3736 Rainier Avenue South

Project Description:

Karen Kiest | Landscape Architects

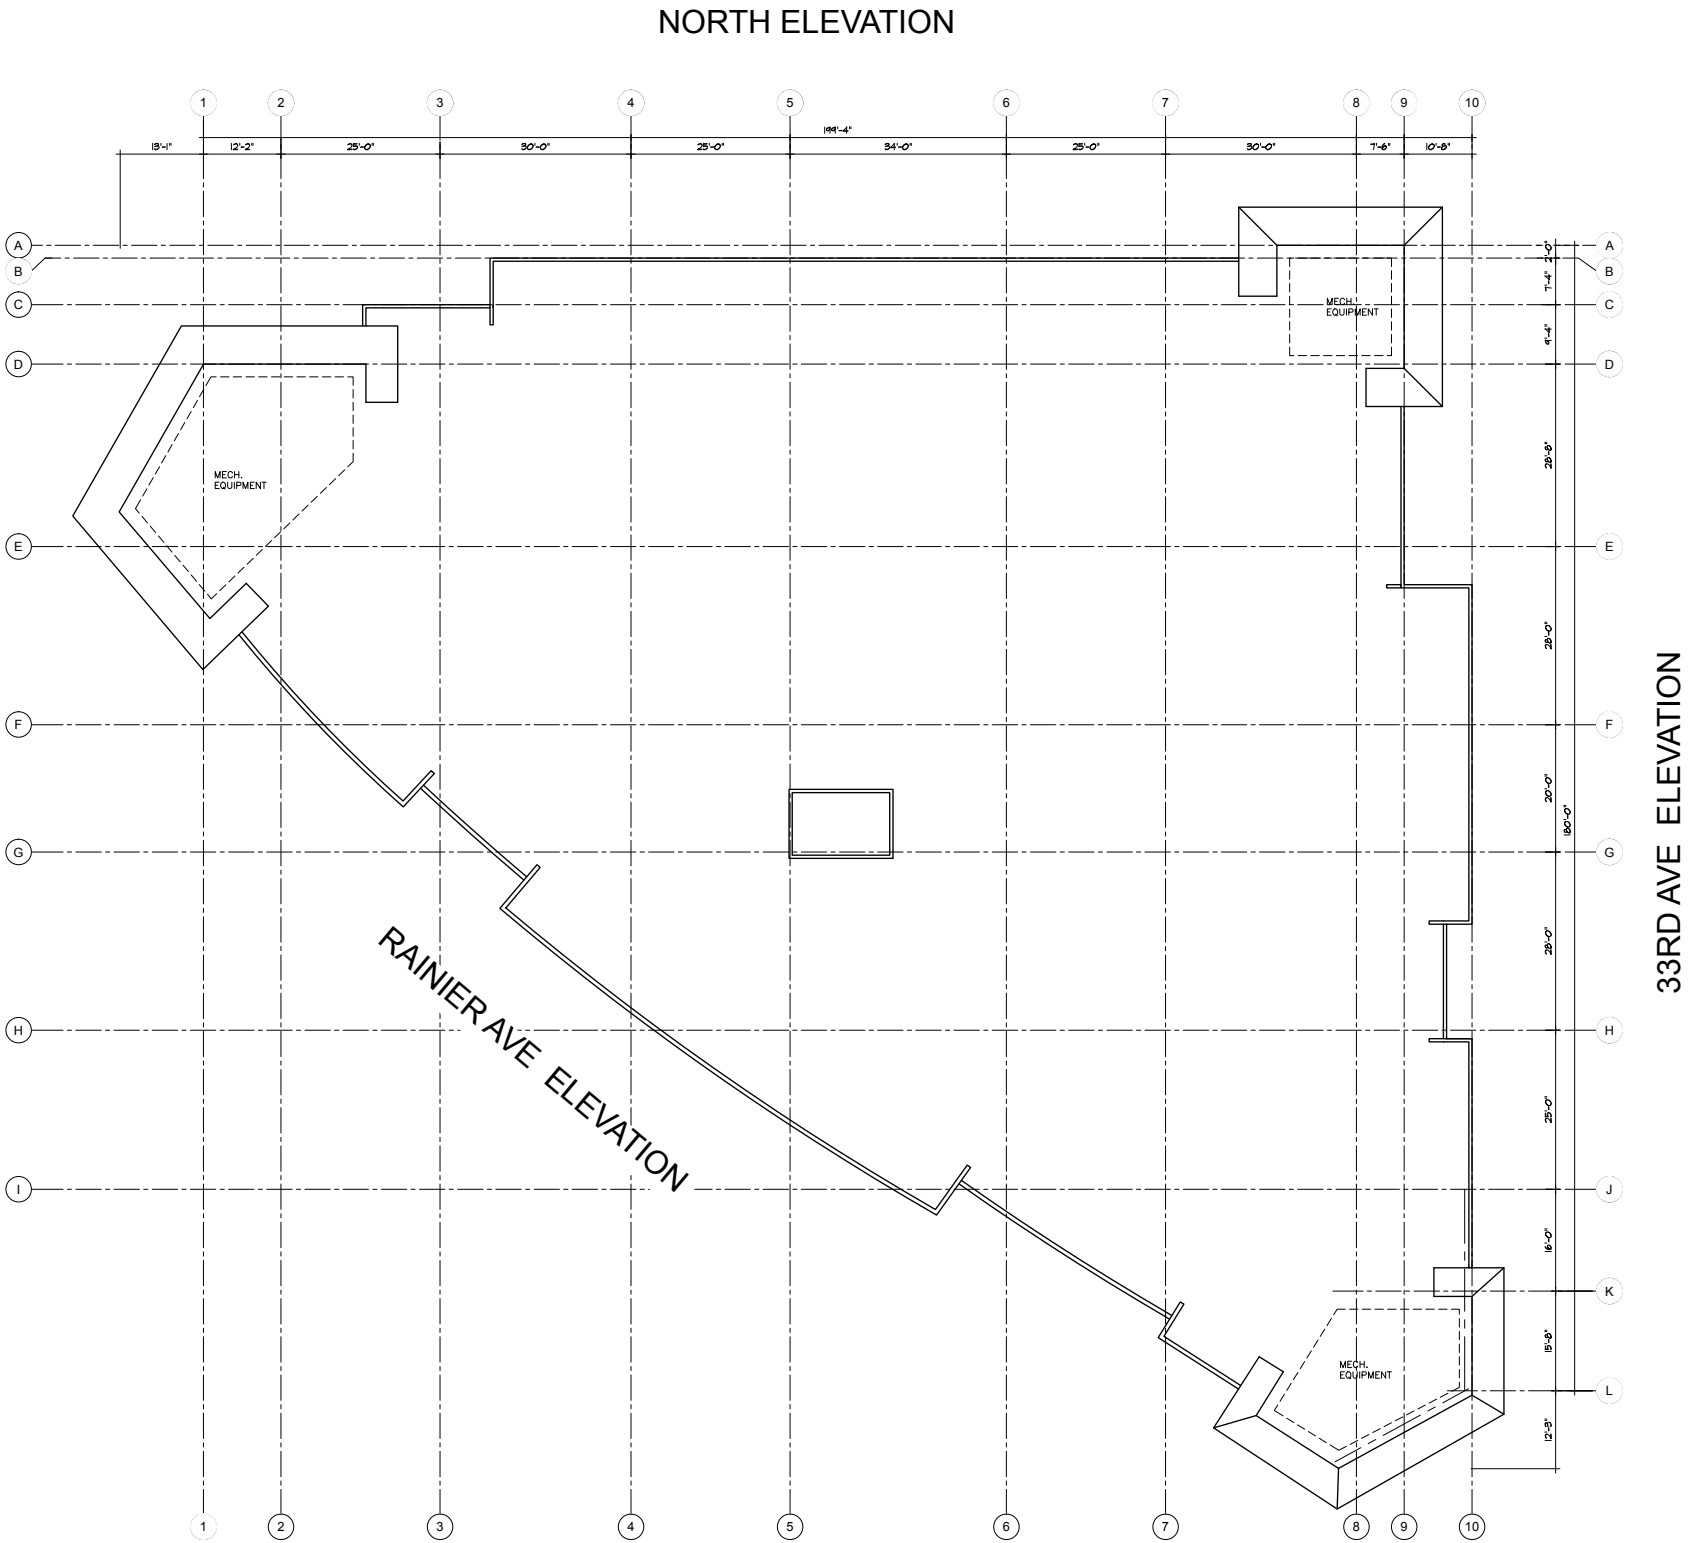
The Board supported the developer's idea to landscape the area between the parking lot and the proposed building façade even though a portion of the area is not on the subject property. The larger square shaped area should be planted with trees capable of maturing to a substantial height in order to mitigate an expansive blank wall.

We have followed the board's recommendation in this area. The various tree species will grown between 15' - 25' in height.

33RD AVENUE (EAST) ELEVATION

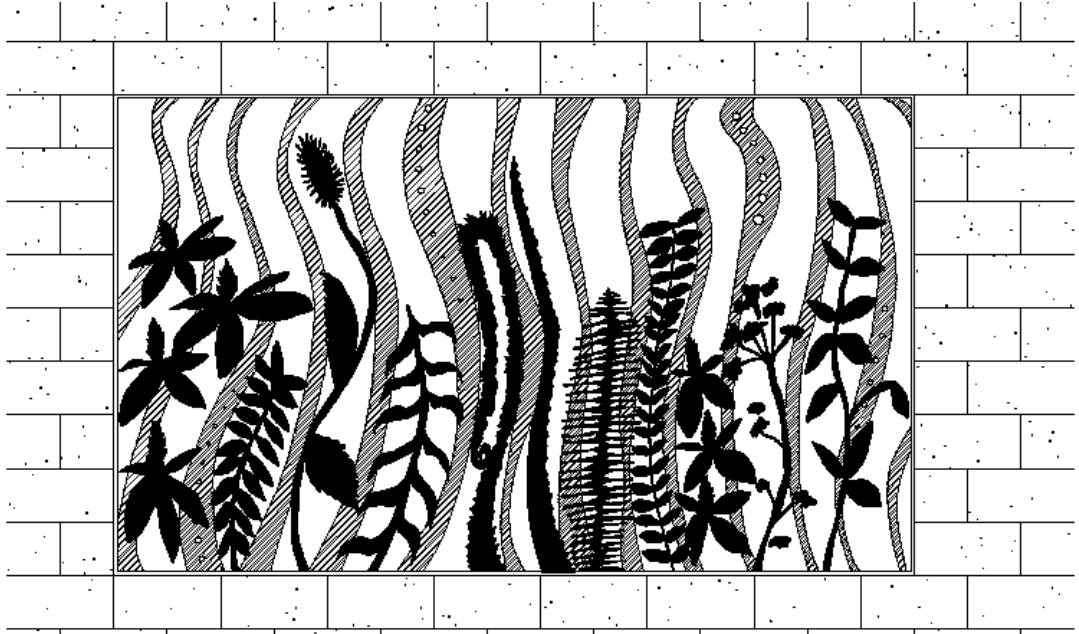
The Board envisions the building's exterior as a large site specific work of art. Lighting the Rainier elevation, creating art screens where the architect has indicated inoperable doors on the 33rd Ave and Rainier Ave elevations, installing interesting landscaping and using fritted glass on some of the elevations would all act to reduce the building's large scale and provide points of interest for pedestrians and the

As discussed above, the orientation and change in materials and the colors somewhat serve to reduce the building's height and bulk. Several other techniques should be employed to diminish the extent of the blank walls. These include adding amenities (benches, interesting paving etc.) at street level, changing the inoperable roll-up doors to artistic panels or decorative grill work and providing continuous canopies that extend over the sidewalk. Revisions to the proportions of the siding may also change the perception of the extensiveness of blank walls.

We've maintained the artistic arrangement of the facade panels. We've incorporated the artistic columns from the adjacent sites into our project. We've taken inspiration from that and the local native vegetation to develop varying artistic panels along the pedestrian areas. The primary concept is a base frame which is directly inspired by the existing neighbor art. On top of that structure we are proposing 10 plants per panel from a pool of 20. This kit of parts will be recombined to make a unique panel for each location while maintaining a consistent palette.

We have worked to adjust the proportions. The palette remains the same as it seemed to be well received. The vertical metal panel patterning has been adjusted for some additional interest.
